Access Compliance Report

Public Rights-of-Way

(Curb Ramps)

Intersection ID: 44062	Main Street: WESTMILL_LN	Cross Street: SEDGEMOOR_LN	Location: E
ADA ID: 58913079AB05	Ramp Type: PerpDiag	Initial Pass/Fail: Pass	Overall Compliance: No
Severity Score: 4.25			
Codes/Mitigation Info/Possible Solution		Field Measurements/Component Compliance

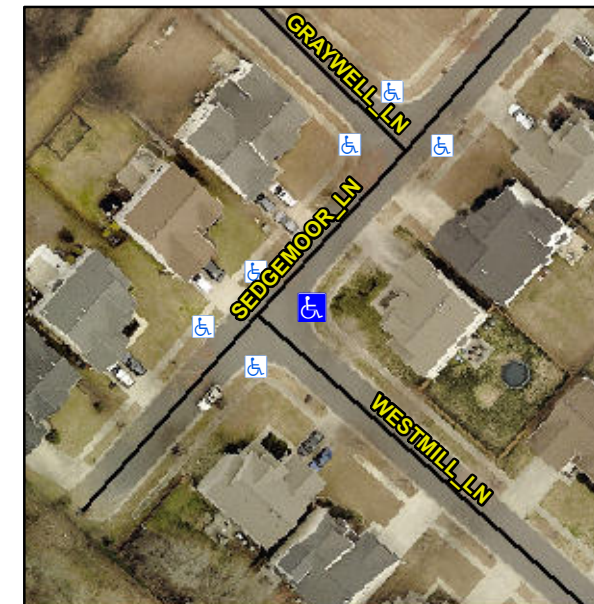
R304.5.3, R304.2.1, R304.2.2-Perp, R304.3.2-Para, R305.2

Compliance	Description	Data	Compliance	Description	Data
N/A	Ramp Length (in)	73.0	Yes	Ramp Slope (%)	5.7
Yes	Ramp Width (in)	66.0	No	Ramp XSlope (%)	3.6
N/A	Flare Type LT	None	N/A	Flare Type RT	N/A
N/A	Flare Slope LT (%)	N/A	N/A	Flare Slope RT (%)	N/A
N/A	Flare Traversable LT?	N/A	N/A	Flare Traversable RT?	N/A
No	Landing Length (in)	47.0	Yes	DWS Provided?	Yes
No	Landing Width (in)	45.0	Yes	DWS Contrast?	Yes
No	Landing Slope (%)	2.4	Yes	DWS Length (in)	24.0
No	Landing X Slope (%)	5.5	Yes	DWS Full Width?	Yes
N/A	Landing Curb? (Y/N)	No	No	DWS Offset (in)	3.0
N/A	Shared Landing?	No			
Yes	Gutter Ponding?	No	Yes	Gutter Slope (%)	2.0
Yes	Gutter Lip Ht (in)	0.0	No	Gutter X Slope (%)	5.6
N/A	Painted X Walk1?	No	N/A	Painted X Walk2?	No
	X Walk 1 Direction	To NW		X Walk 2 Direction	To SW
N/A	X Walk 1 Width (in)	N/A	N/A	X Walk 2 Width (in)	N/A
	X Walk 1 Slope (%)	1.0		X Walk 2 Slope (%)	1.6
	X Walk 1 X Slope (%)	2.3		X Walk 2 X Slope (%)	3.4

N/A	Ramp inside XWalk1?	N/A	N/A	Ramp inside XWalk2?	N/A
	Road Slope (%)	3.7	N/A	Clear Space?	Yes
	Road X Slope (%)	0.5	N/A	Clear Space to XWalk (in)	N/A
Yes	Any Obstructions?	No	Yes	Storm Grate/Utility Hazard?	No
	Obstruction Type			Storm Grate/Utility Type	
		N/A			N/A
			Yes	Surface Condition? (G/P)	Good

Remove & Replace Curb Ramp With Two New Directional Ramps or Equivalent. Remove & Replace Gutter.
